FED. ROAD DIST. NO.	DIVISION	PROJECT NO.	SHEET NO.	TOTAL SHEETS
9	COLO.	125-3(35)258	53

COLORADO
 DEPARTMENT OF HIGHWAYS
 3 SPANS @ 28'-0" B.W.D., 3 SPANS @ 30' No. B.W.D.
 CONCRETE SLAB & GIRDERS, 38 Rows. 2 Cures
 GENERAL LAYOUT, SUMMARY of QUANTITIES and GENERAL NOTES
 Across County Road
 Sta. 2753+00
 Near KELVIN Sec. 34 T. 6N R. 68W
 Designed by *A. D. Newcomb*
 Made by *A. J. P.*
 Checked by *A. J. P.*
 Approved by *A. D. Newcomb*
 Bridge Engineer
 Date: Sept. 16, 1963

C-17-ES No. BOUND
 STRUCTURE NO. C-17-EI So. BOUND

COLORADO DEPARTMENT OF HIGHWAYS
 MISCELLANEOUS BRIDGE DETAILS
 Across... County Road
 Sta. See Above
 Near Kelim Sec. 34 T. 6N R. 68W
 Designed by [Signature]
 Made by [Signature]
 Checked by [Signature]
 Approved by [Signature]
 Date: Sept. 16, 1963

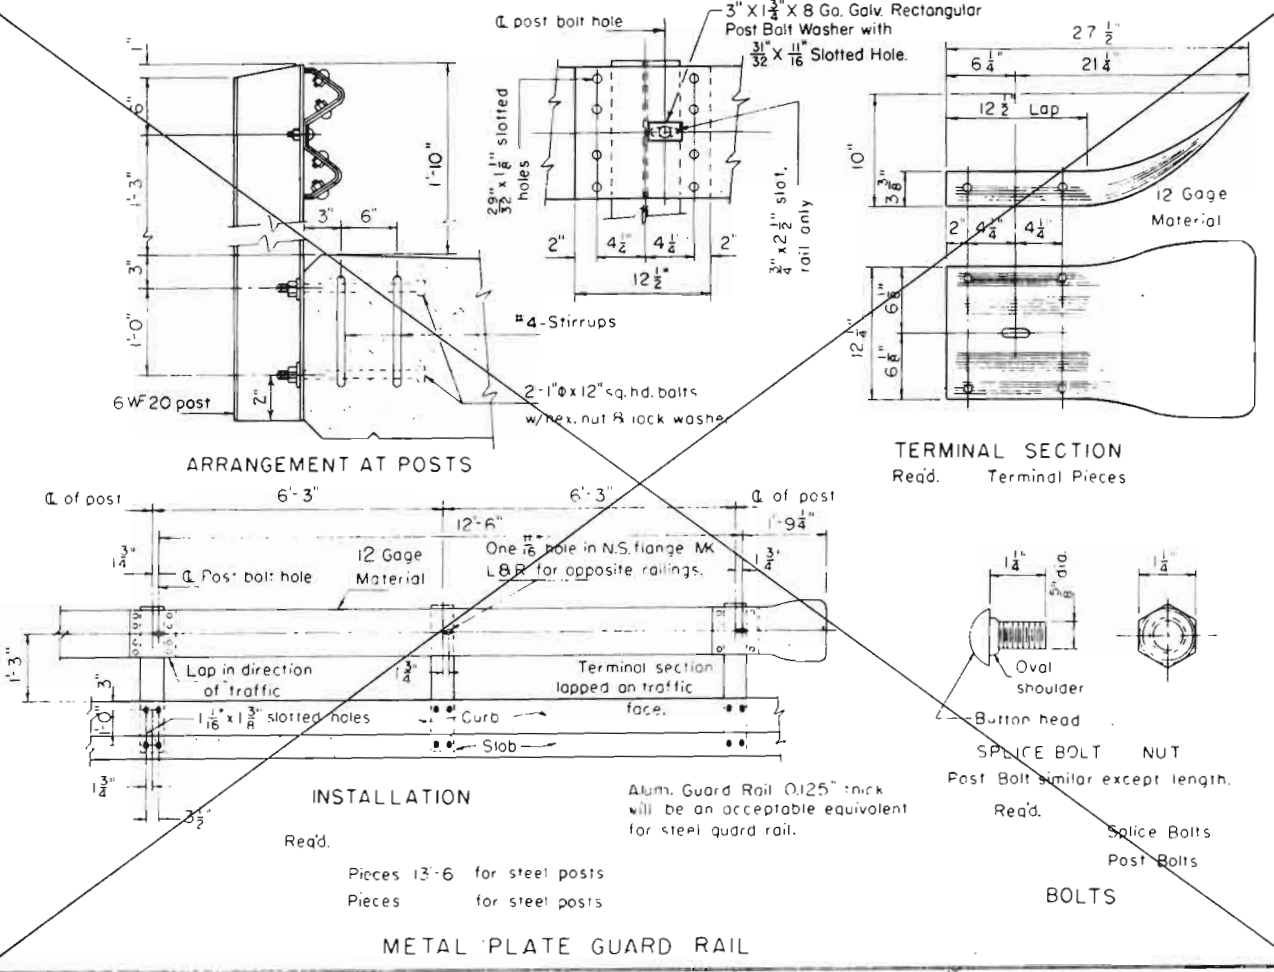
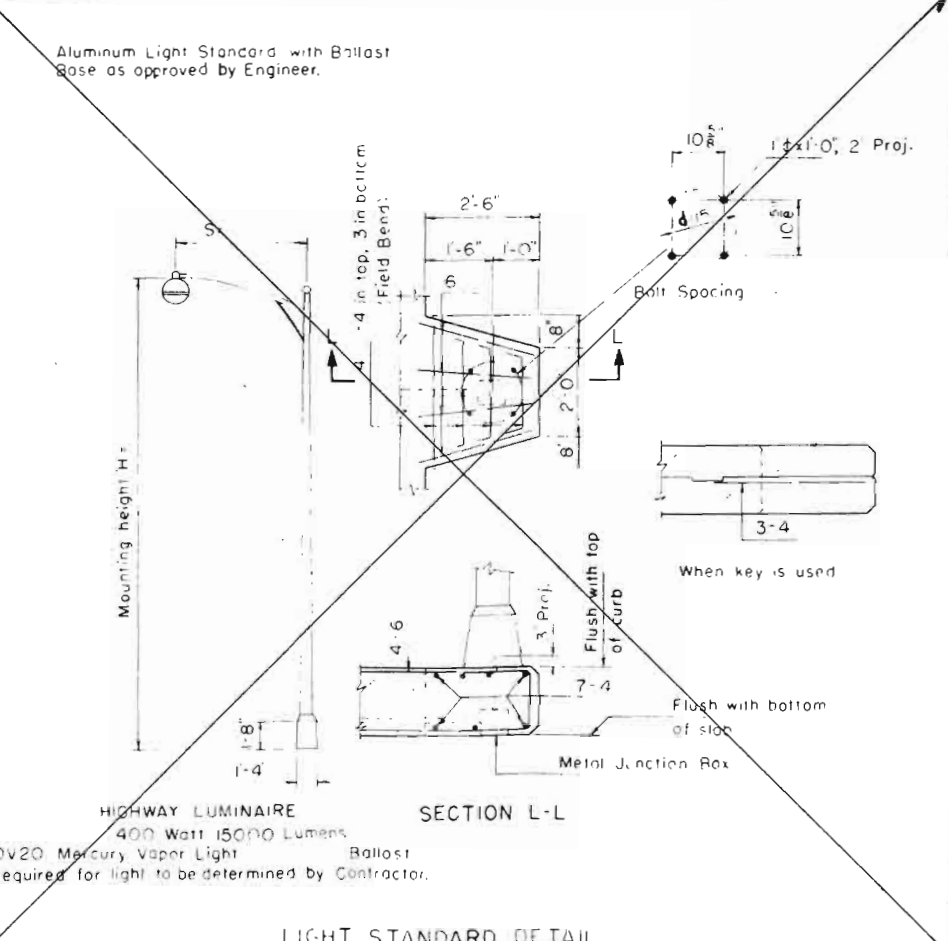
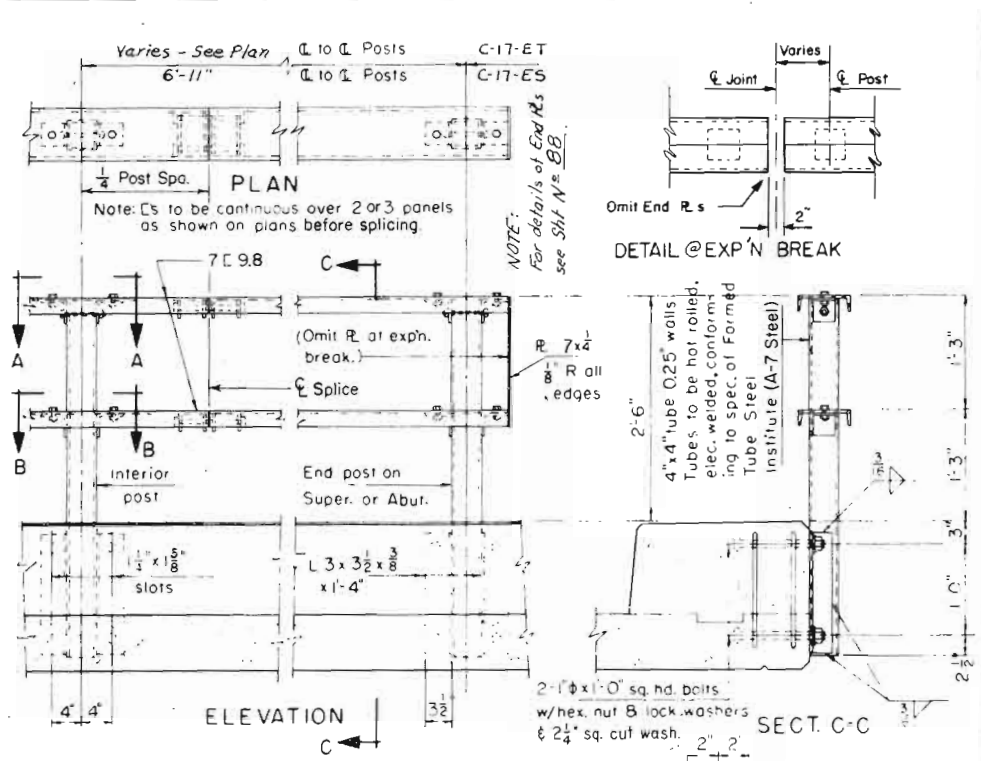
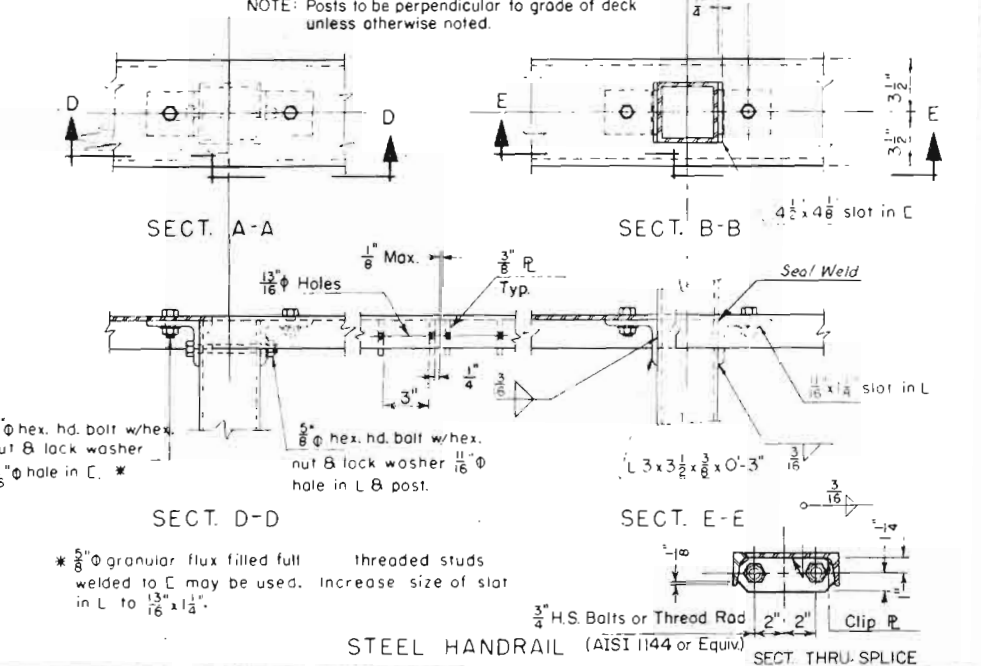
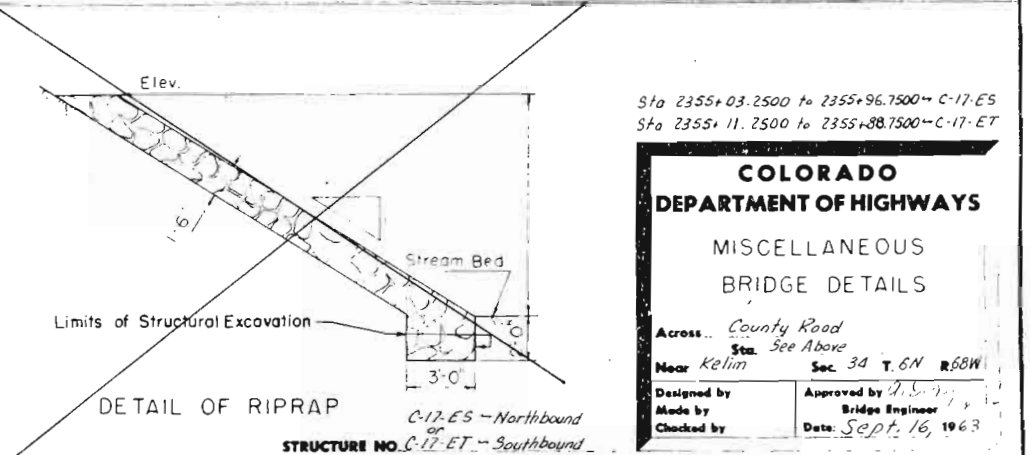
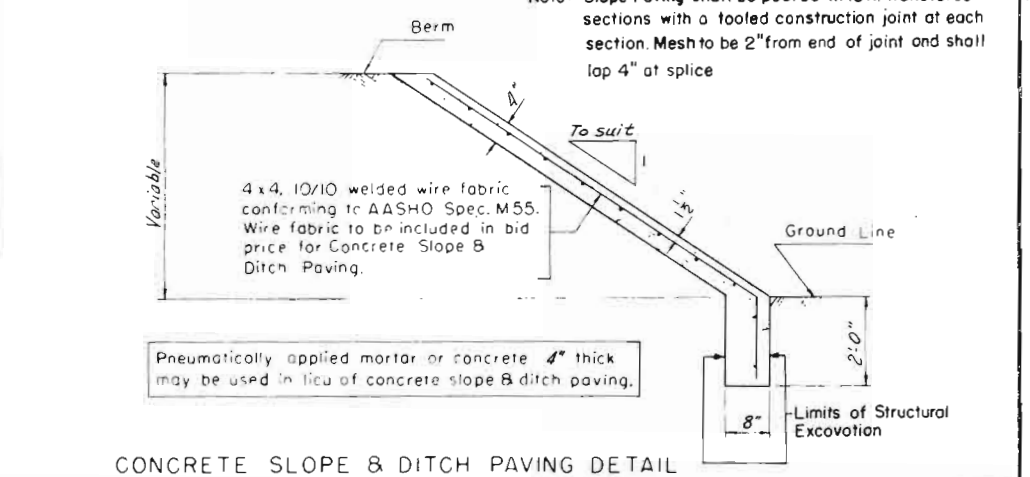
Rev. Handrail post spacing & Sta. for C-17-ET. 3-19-64 D.S.M.
